SERVICE BULLETIN

DATE: 24 DECEMBER 1976
PAGE 1 OF 4

INSPECTION - TALL ROTOR DRIVE SHAFT DAMPER, PN 369A5506

Figure 1. Inspection - Tail Rotor Drive Shaft Damper, PN 369A5506

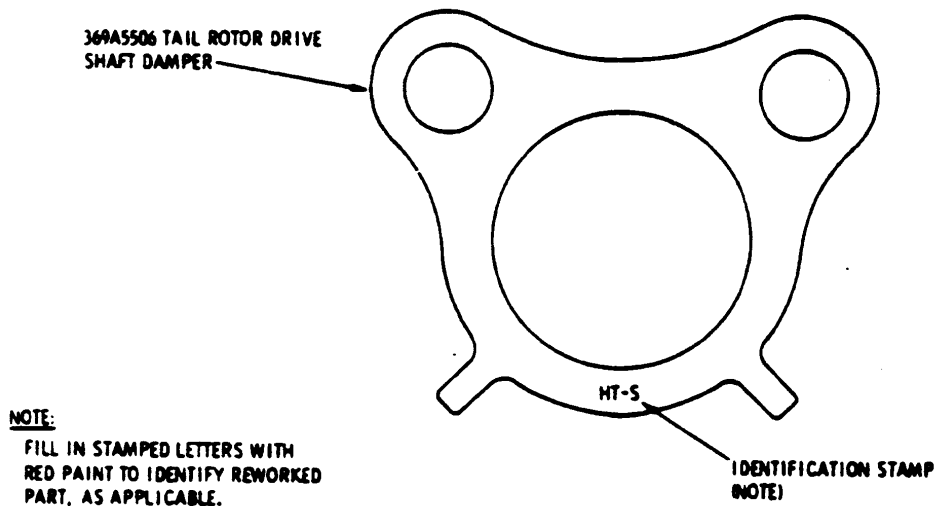
- (1). Remove tail rotor, tail rotor transmission, tail rotor drive shaft and tail rotor drive shaft damper assembly, per Basic HMI
- (2). Visually inspect drive shaft damper as follows:
 - (a). Damper block identified with stamp "HT-S", or a heat lot number on opposite side from "HT" stamp, is acceptable for continued service (see Figure 1).
 - (b). Damper block not having letter "S" in identification stamp, or not having heat lot number on opposite side from "HT" stamp, must be reworked or replaced.

- (1). At each 10 hours of helicopter operation:
 - (a). Displace damper so that it touches drive shaft.
 - (b). Using wire gage, measure damper to shaft clearance 180° from the contact point. Minimum acceptable clearance is 0.010 inch.
 - (c). Repeat measurement at 90° intervals from initial check point.
- (2). Record compliance with Part II of this Notice in Compliance Record of helicopter Log Book.

- (1). Disassemble tail rotor drive shaft damper assembly.
- (2). Measure inside diameter of damper block bore.

- (3). Using any oven with thermostat control, preheat oven to 350°F; place damper block on flat metal sheet and bake block for two hours at 350 deg. F. Turn oven off and allow block to cool to approximate room temperature.
- (4). Measure inside diameter of damper block bore.

- (5). Machine bore out-of-tolerance damper block to 2.905/.2.910 inches diameter. Use slow feed; finish block bore to a surface finish of 32.

NOTE: 1. If ID of bore is greater than 2.960 inches, return part to service; perform steps 14 thru 16 below.

2. If ID of bore is less than 2.960 inches, record ID dimension and perform step 3 below.

NOTE: 1. If ID of bore is 2.905 inches or greater, return part to service; perform steps 6 thru 8 below.

2. If ID of bore is less than 2.905 inches, perform rework per step 5 below.

- (6). Fill stamped letters on damper with red paint to identify reworked part.
- (7). Reassemble and install parts and assemblies, per Basic HMI.
- (8). Perform operational check of tail rotor system.
- (9). Record compliance with Part III of this Service Information Notice in Compliance Record of Helicopter Log Book.
